Extension to the Carob Tree Restaurant Highgate, Camden

Title:
Comparison of Existing, Appeal and Newly Proposed Alley Way Elevation

Scale: 1:50 (@A1)	Date: SEPT 11'
Drawn By: S.G.D	Checked: D.U.
Drawing No. SA/PL/101/19	Revision

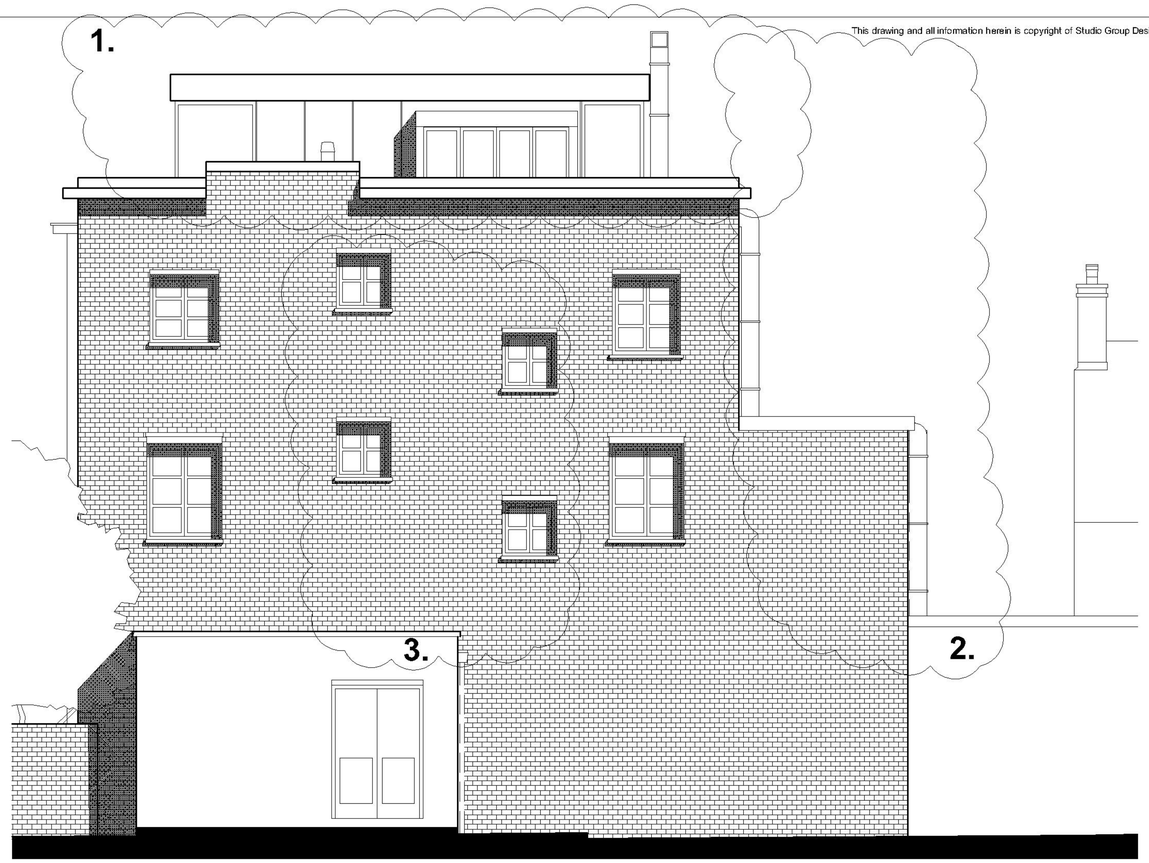
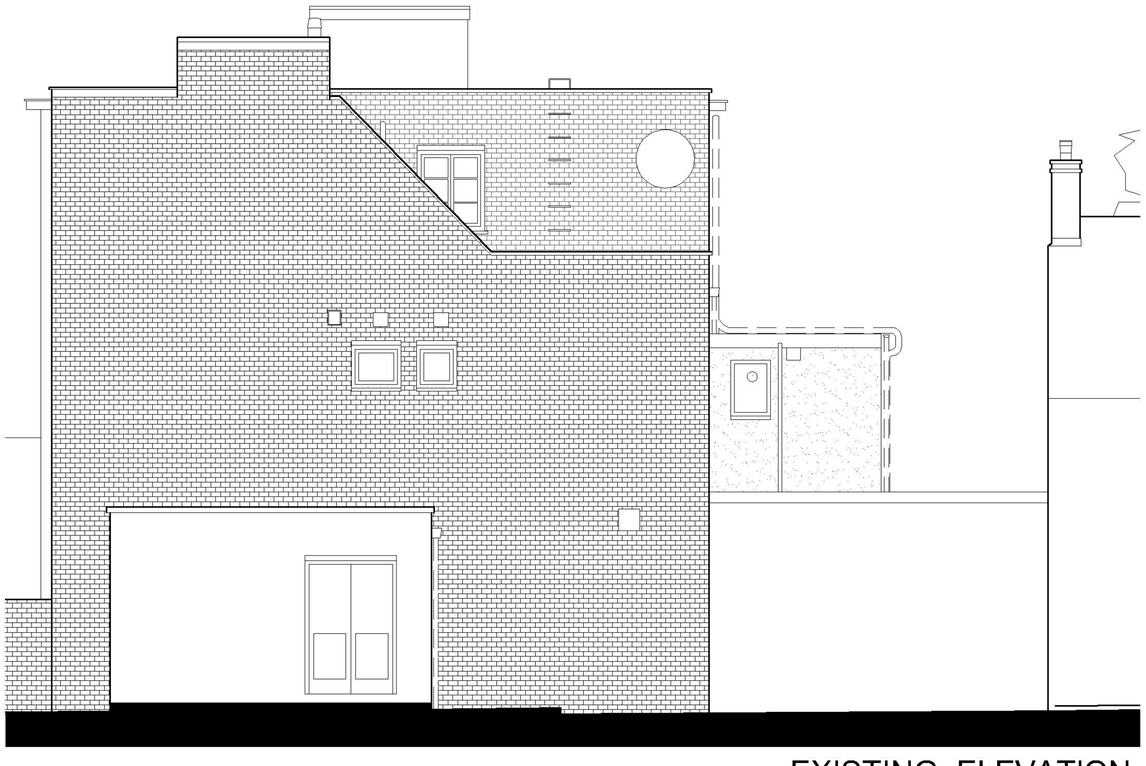
Main Changes from Appeal to New

1. The roof extension has been reduced in size in line with a reduction to the overall mass of the building on Swain's Lane

2. Staircase extension removed in line with inspectors comment. First floor extension added to reflect new plan layout, but existing gap to the existing building has been restored.

3. New window layouts created to reflect the staircase in the revised floor plans.
